**Tennessee Valley Authority
Regulatory Submittal for Kingston Fossil Plant**

Valley Area #2 Temporary Storage Work Plan, Revision 1

Re: Stability Evaluation of Temporary Ash Storage
Dredge Cell Valley Area
Kingston Fossil Plant
Harriman, Roane County, Tennessee

Section 1 - Valley Area, South End, Parallel to Dike D

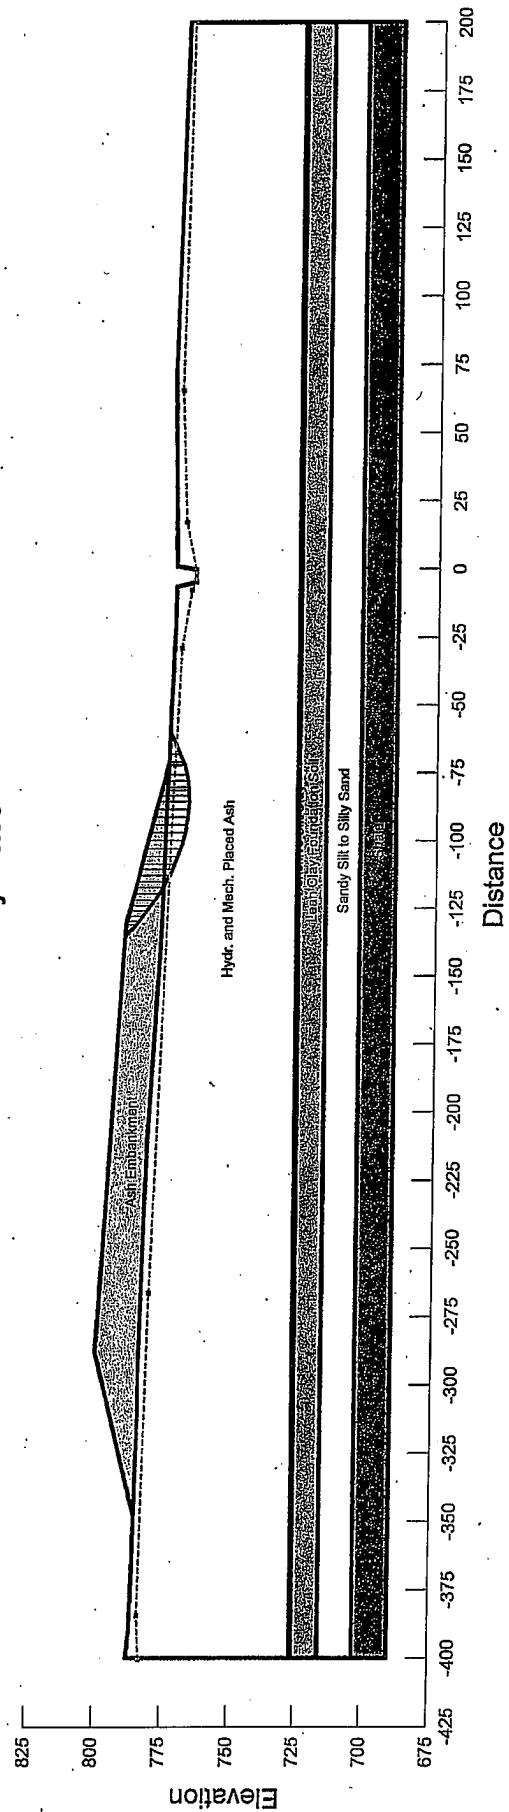
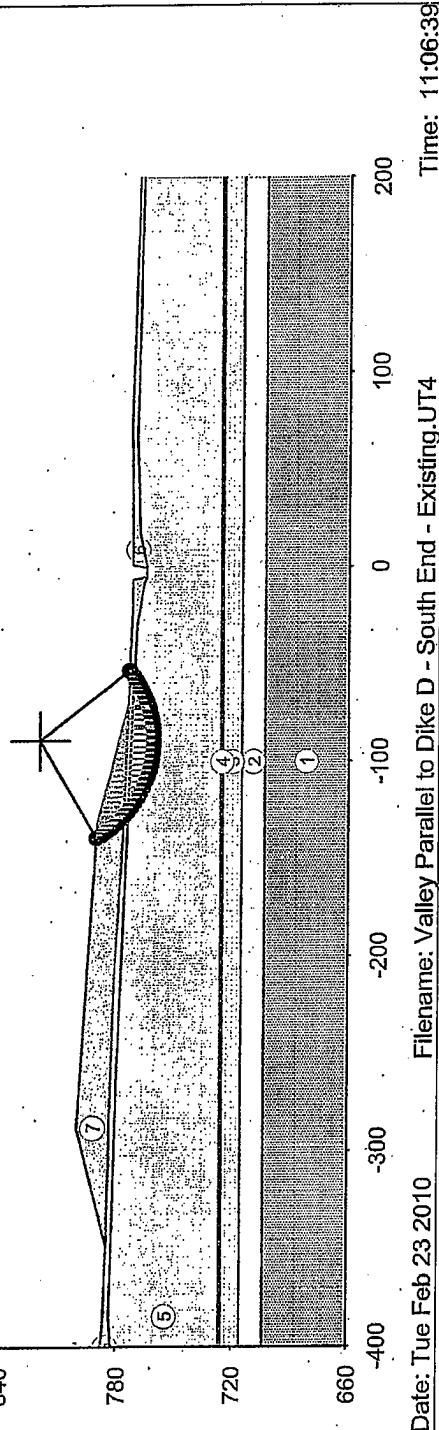
Cross Section	Critical Factors of Safety	
	Drained Condition	Undrained Condition
Section 1 (South End, Parallel to Dike D)	1.98	1.42
Section 2 (North End, Parallel to Dike D)	2.61	1.72 (Stage 1) 1.82 (Stage 2) 1.32 (Final Stage)
Section 3 (Perpendicular to Dike D)	1.79	1.33

Section 2 - Valley Area, North End, Parallel to Dike D, Stage 1

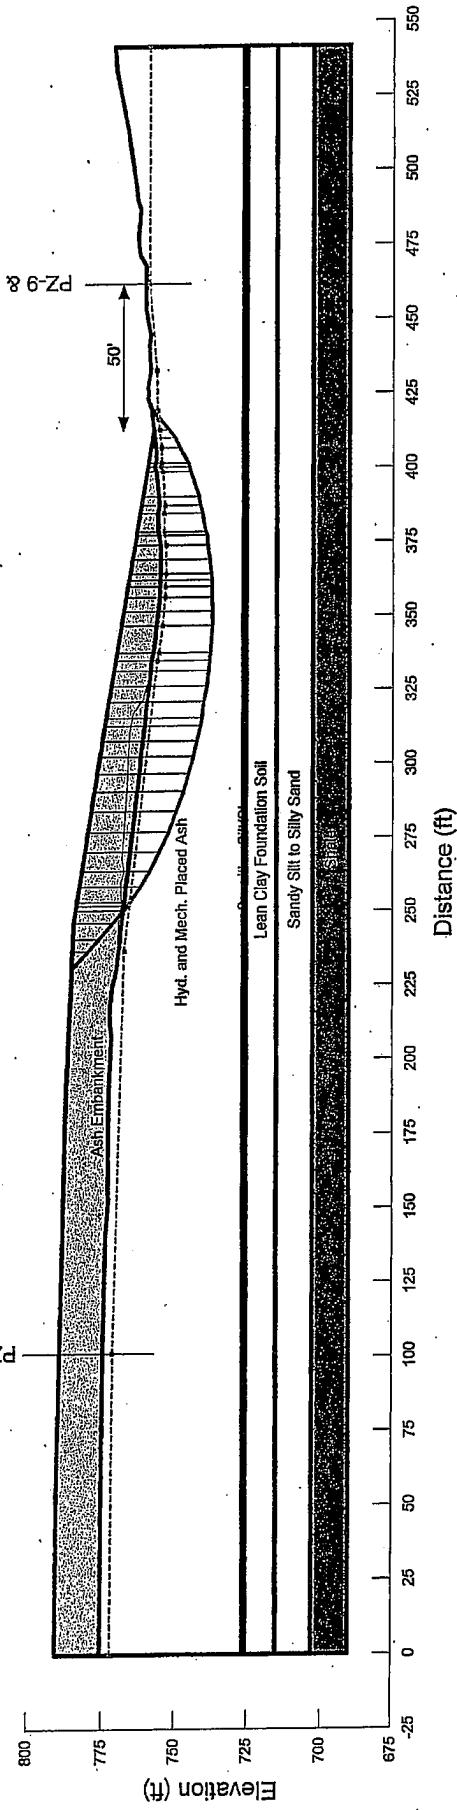
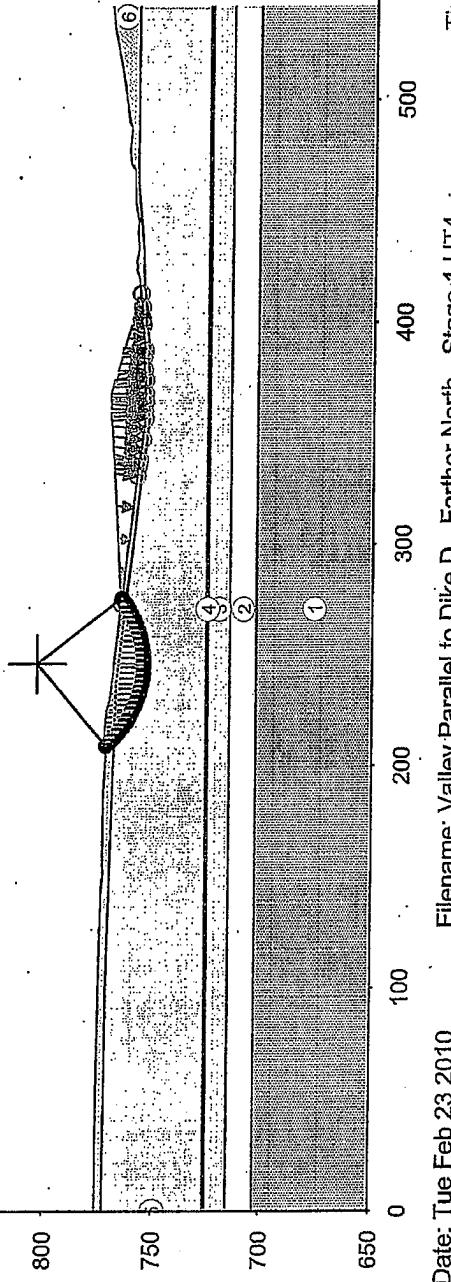
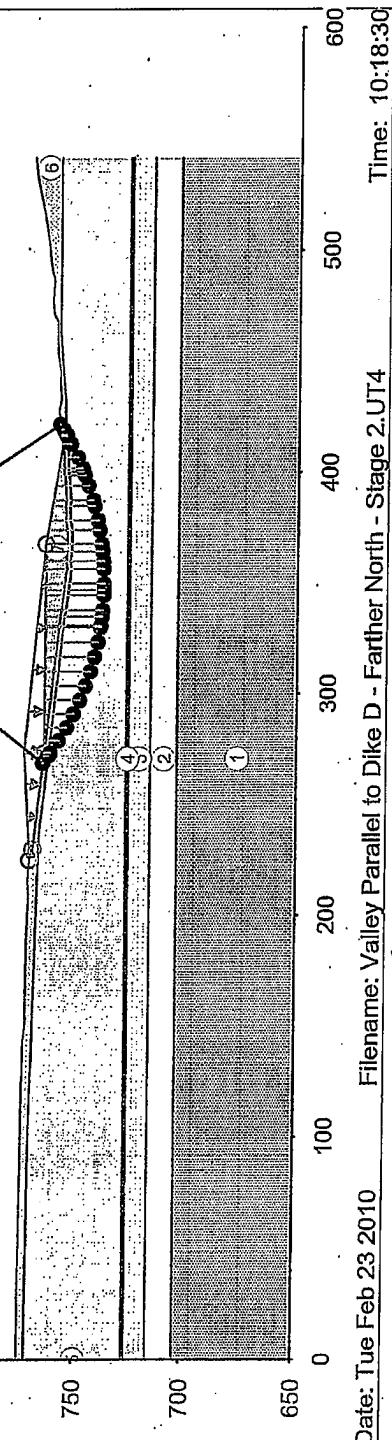
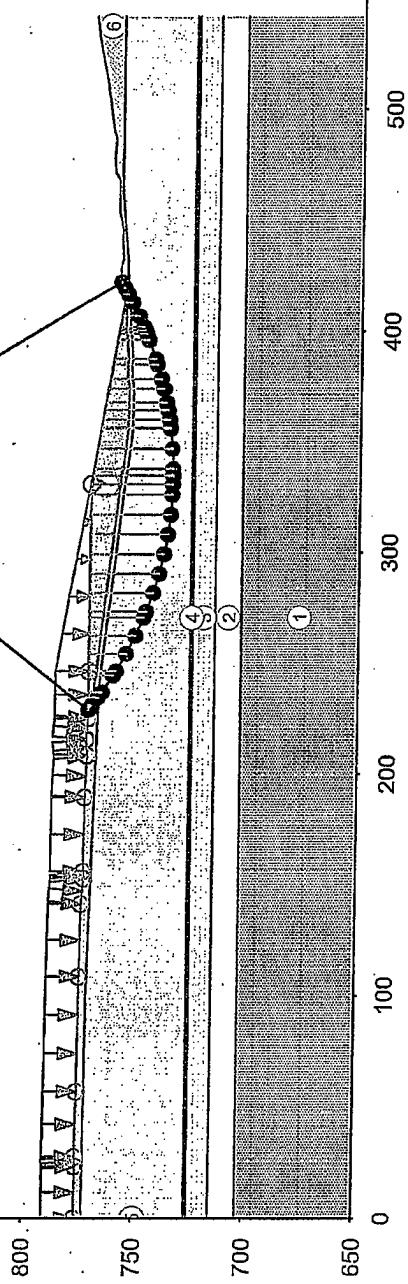
3. Embankment material should consist of unsaturated ash. The sequence of filling should commence at the lowest section (in elevation) of the subject footprint (to the approximate Stage 2 geometry shown in the enclosed computer output plots) and proceed upward in maximum 24-inch loose lifts in a manner to maintain positive drainage at all times. Each lift should be fully tracked-in-place with appropriate equipment.
